***MODIFICATION ASSESSMENT
Remediation of the Former Lednez Site,
Rhodes, and Parts of the Bed of
Homebush Bay***

Environmental Assessment Report
Section 96(2) of the
Environmental Planning and Assessment Act 1979

February 2007

Figure 2 – Proposed (Modified) Desorption Facility Location

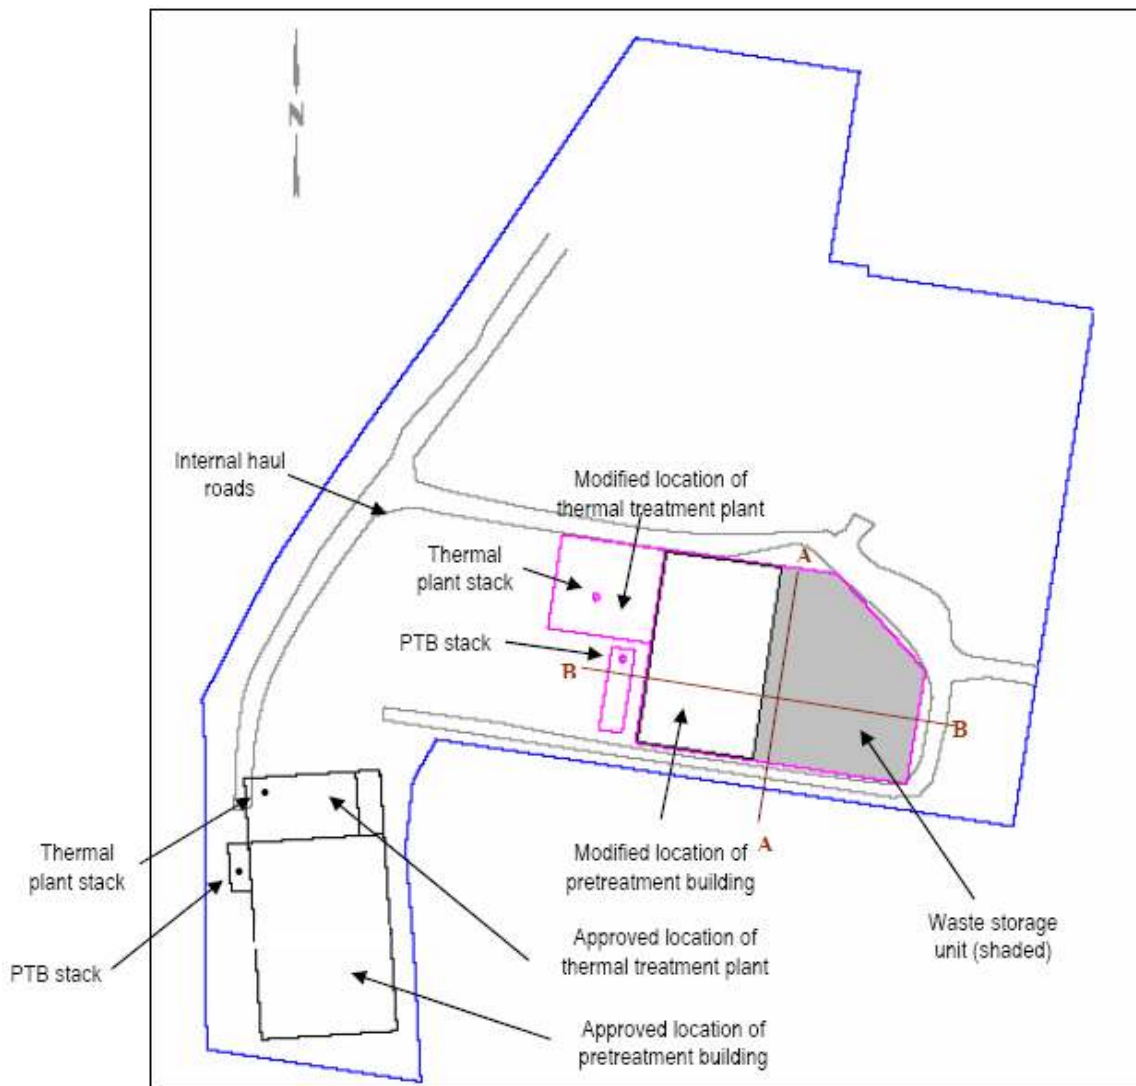
The modification also seeks to relocate the approved location for the desorption plant. The proposed location is shown in Figure 2.

The waste storage unit (indicated in Figure 2), utilised for the temporary storage of material destined for thermal treatment, is proposed to be enclosed using a cable supported tent made of shade cloth-like material. The material proposed for the enclosure would be a heavy duty black woven high density polyethylene plastic. The enclosure is proposed to reduce odour emissions.

Figure 3 – Proposed Multi-Barrier Containment System

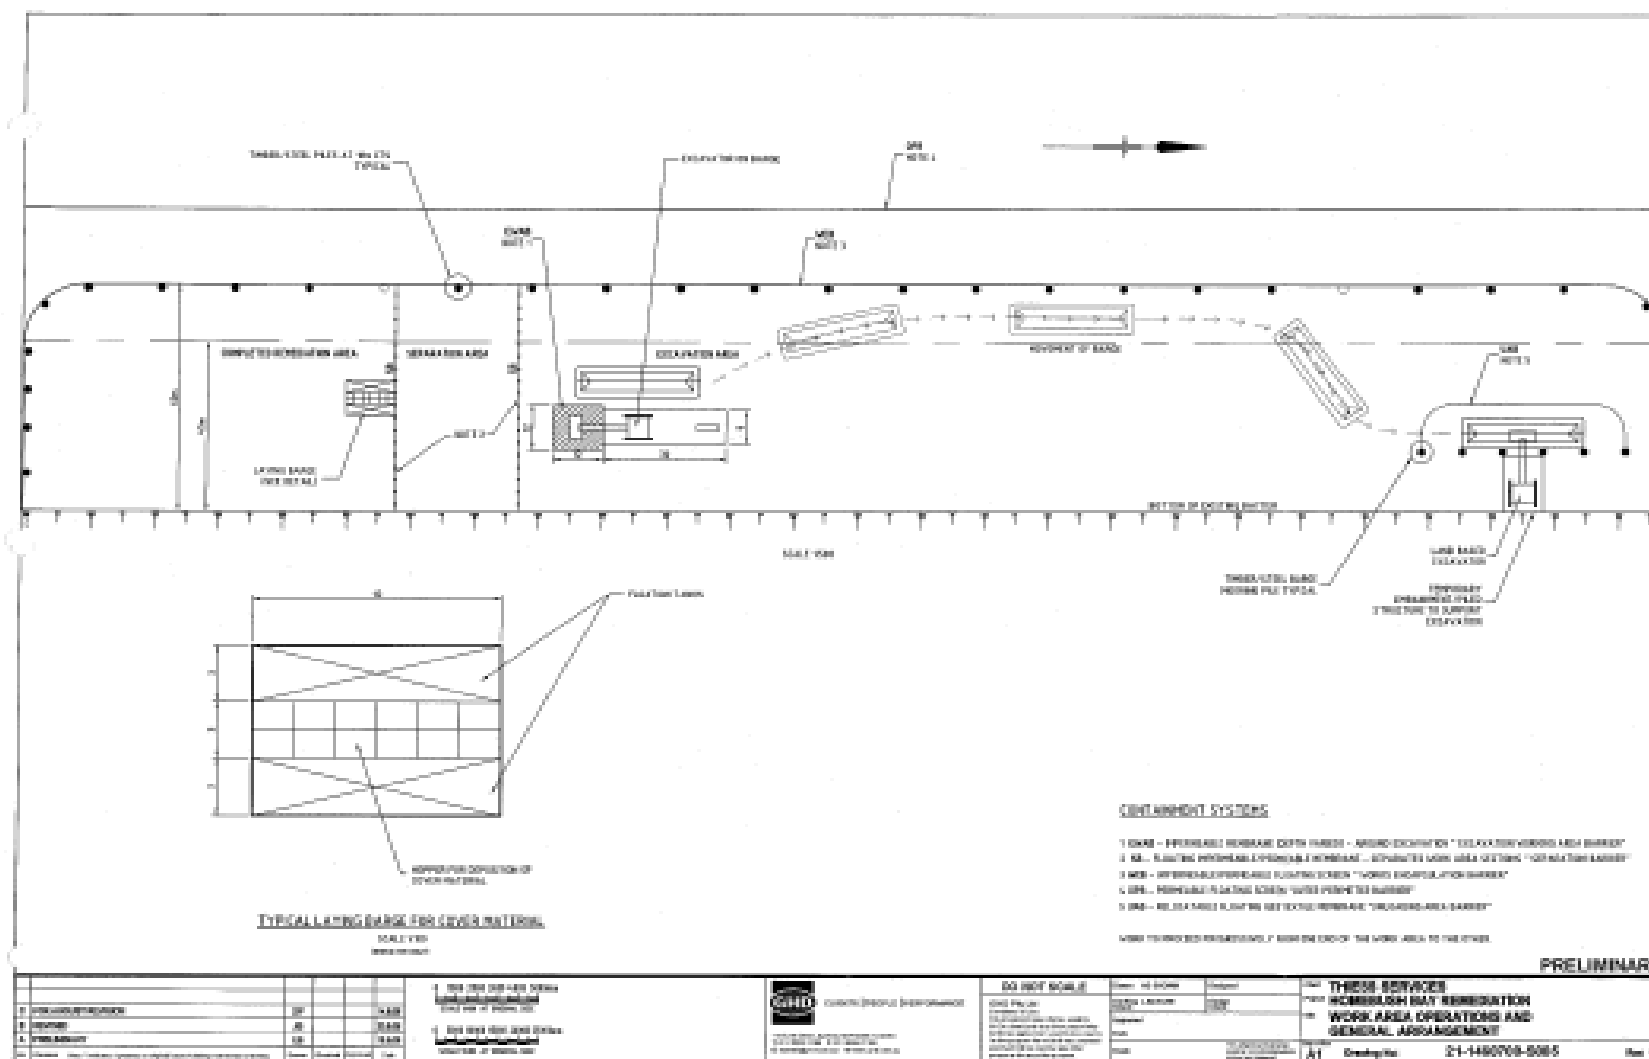
The success of the multi-barrier containment system to control suspended sediment releases would depend to a significant extent on the correct installation and integrity of the system during sediment removal, and the proper operation/maintenance of the containment system by the operators. The Applicant proposes to trial the multiple barrier sediment containment system prior to its implementation on a large scale. The Department considers that the proposed trial would be critical in refining the design of the containment system and therefore a condition has been included in the modifying instrument requiring the Applicant to submit details of the trial's methodology and monitoring for the approval of the DEC and the Director-General. During the trial, monitoring of water quality will be undertaken and the integrity of the system will be tested on a smaller scale. The Department has also included conditions requiring the preparation of a Bay Remediation Management Protocol, for the approval of the DEC and the Director-General, which must incorporate all of the monitoring requirements, trigger levels and limits, contingency actions, safety procedures, containment system installation procedures and for the continuous inspection and maintenance of the barrier containment system during operation. The results of the containment system trial would be used in the development of the Bay Remediation Operational Management Plan.

In relation to the mobilisation of soluble contaminants from the sediments into the water column, the Department considers that controlling sediment generation will assist in minimising the solution of chemicals in water. The Department also considers that given the significance of this issue further information of potential chemical mobilisation during sediment excavation is required prior to Bay remediation. From the solubility elutriate testing conducted as part of the modification application's investigations the Applicant concluded that the solubilisation of

chemicals during the proposed bay works was not anticipated to represent a significant risk to bay water quality. The Department considers that elutriate testing provided some positive results but that no definite conclusions could be made on such investigations. In this regard, the Department acknowledges the difficulties in replicating in the laboratory the conditions that will occur during dredging. The Department also notes that the elutriate samples analysed as part of the modification application were settled for 18 hours (instead of one hour settlement required under the USEPA elutriate test method) and therefore there is the risk that concentrations may have been underestimated. To this end, the Department believes that further refinement of this data is necessary prior to implementation is required.

A number of conditions have been included in the recommended approval to address the solubilisation of chemicals during dredging operations. Water quality sampling will be undertaken during the containment system trial and that will provide the most accurate representation of the water quality conditions that will be expected during bay remediation. The Applicant will also be required to undertake additional solubility testing if the impact of soluble chemicals has not been addressed prior to the bay remediation works to the satisfaction of the DEC. The results of these investigations will be used to further reduce the risk of chemical mobilisation into the water column.
